# UNITED STATES PATENT AND TRADEMARK OFFICE

APPLICATION NO.	FILING DATE	FIRST NAMED INVENTOR	ATTORNEY DOCKET NO.	CONFIRMATION NO.
10/817,055	04/02/2004	Yves R. Hoarau	HOARAU-01	2228

## Office Action Summary

## DETAILED ACTION

FIG. 8

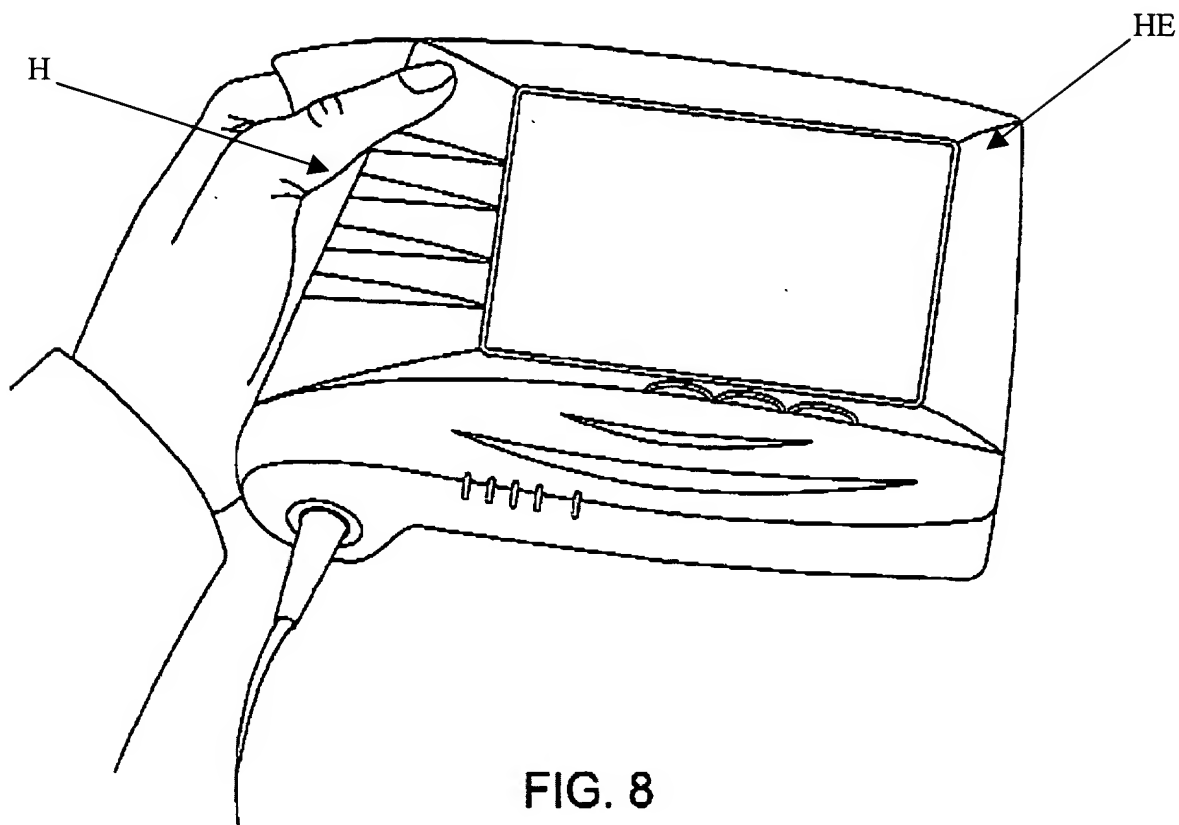
1) Claims 1-10,13-20,23,25,44 and 48 are rejected under 35 U.S.C. 103(a) as being unpatentable over Barnes et al. Barnes et al disclose an intraoral data input tool 100, said tool comprising: a handle 114, and a head 118 attached to a first end of said handle 114, said head 118 including a data input device 100, said data input device 100 being responsive to force applied by a stylus 122, said head 118 being configured to allow a dental examiner to input data using said stylus on said input device when said head is positioned at least partially within said patient's mouth. In an alternate embodiment, Barnes et al shows handle (H), as shown in Figure 8 (copied below for clarification), being generally cylindrical, the diameter of the handle being much smaller than the length of the handle, said handle being capable of being held in between the thumb and first and second fingers of a dental examiner's hand. Figure 8 also shows a head (HE), which is generally flat and thin. This also anticipates Claim 16. As to Claim 4, the data input device 110 comprises a multiplicity of push buttons 128,132,134. Regarding Claims 6-8, the data input device 110 comprises a touch sensitive display 110 (see column 4, lines 43-47); the screen 110 acts as a mirror; and the multiplicity of push buttons 128,132,134 are located peripherally about said mirror. With respect to Claim 10, the screen 110 is also considered a display. As to Claim 14, the tool 100 further comprises an electrical connector 210 (as shown in

Figure 2) attached to a second end of said handle 114, and an electrical cable 212 connecting said electrical connector 210 to said data input device 110. Regarding Claims 15 and 17, the stylus 122 is capable of functioning as a dental probe. As to Claim 18, the system 100 further comprises a controller 214 with an operating program, said controller 214 being linked to said intraoral data input tool 110 by a communication means. Regarding Claim 19, the communication means comprises an electrical cable as shown in Figure 2 hanging from the bottom of the device 100. Barnes et al also disclose a dental data input system 100 wherein said communication means is a wireless communication means 123. To Claims 23 and 25, the dental input system 100 comprises a display 110 electrically connected to the controller 214; and a keyboard or auxiliary input device 128,132,134 electrically connected to the controller 214. Obviously there is some sort of operating program within this device. To claim 48, push buttons (128,132,134) display (110) is touch sensitive (see column 4, lines 43-47). Barnes et al does not teach the largest dimension of the head being 2.5 centimeters as in the amended version of claim 1 or as to claim 44, the length of the handle being approximately 13 centimeters. It would have been obvious to one having ordinary skill in the art at the time the invention was made to incorporate the dimension and length as claimed, since such a modification would have involved a mere change in the size of a component. A change in size is generally recognized as being within the level of ordinary skill in the art. *In re Rose*, 105 USPQ 237 (CCPA 1955).

As to claims 2,5,9,13, and 48 Barnes et al disclose the claimed invention except for the discoid head. It would have been an obvious matter of design choice to manufacture the head of the device having a discoid shape, since such a modification would have involved a mere change in the shape of a component. A change in shape is generally recognized as being within the level of ordinary skill in the art. Further to claim 9, head (118) obviously has a first and second parallel flat surfaces, otherwise display (110) would be held in a slanted orientation.
